Error E9 or switching errors on Pelican user interface

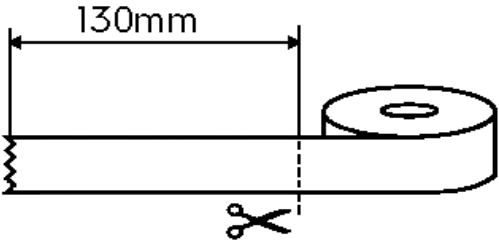
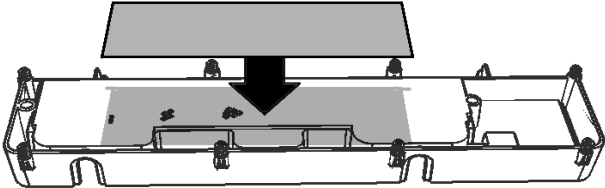
During operation of a radiant heater, rise of temperature may cause a rise of humidity level. If the humidity enters the Everest protection box, it condenses and causes malfunctions. This can be observed as either an E9 error or various errors switching on the display

<p>1. Remove the power board protection box from the appliance. Be careful not to lose the springs.</p>	<p>2. Locate ventilation holes on the bottom.</p>

To prevent this error it necessary to block the possibility of humidity entering the inside of the box. This should be done as a pre-emptive action during any repair on hobs listed at the end of this bulletin.

To perform this repair it is required to order aluminium adhesive tape 1525001002 and follow instructions below.

<p>3. Prepare a 130mm strip of adhesive tape 1525001002.</p>	<p>4. Place tape as shown on the picture. Be sure that it completely covers the holes.</p>
